Atherton Hospital Redevelopment

MAIL TYPE	MAIL NUMBER	REFERENCE NUMBER
Response to RFI	PTA 1-RTRFI-001989	FKG-RFI-001227

Re: URGENT - Level 1 Rectification Alternative

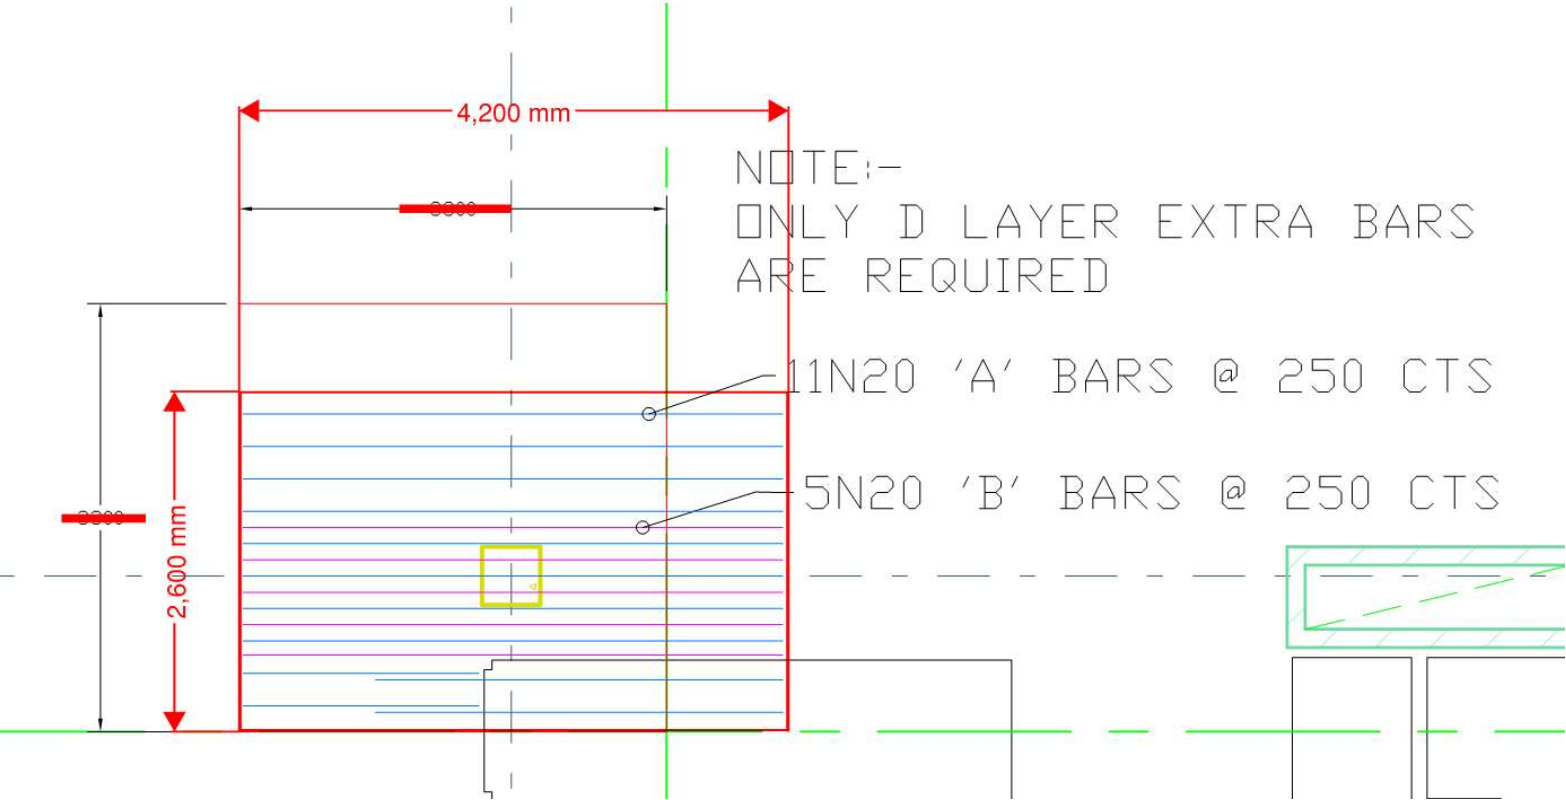
As discussed on the phone with Daniele this afternoon, please confirm if the below area of proposed demolition (4.2m x 2.6m) and potentially pedestal could be adopted during these rectification works.

The proposed demolition extent is acceptable. It is understood that on the southern side of grid 3 the demolition will extend up to the construction joint.

We will be able to confirm extent of drop panel, confirm acceptance of proposed concrete mix and issue the for construction drawing by the end of the week.

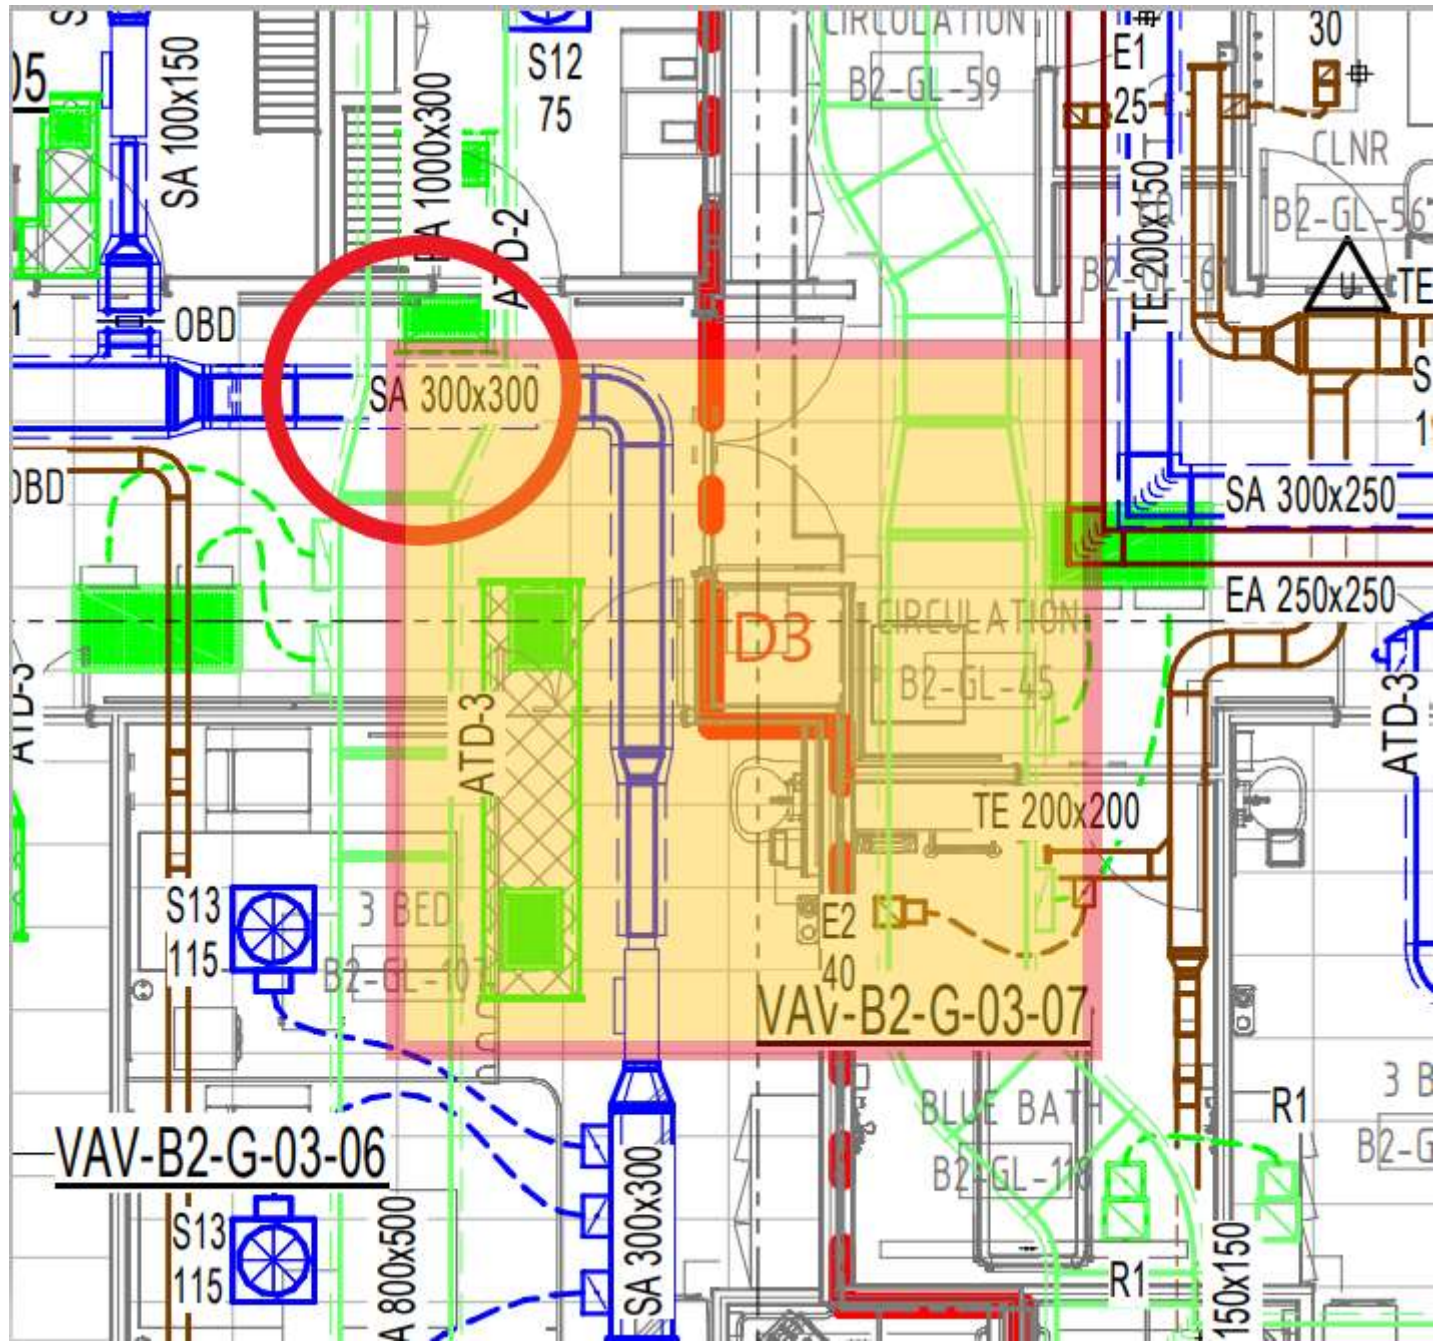
We note that it will have a minor clash with some of the mechanical ductwork shown circled below.

However we anticipate that this will be coordinated between yourselves and VAE?
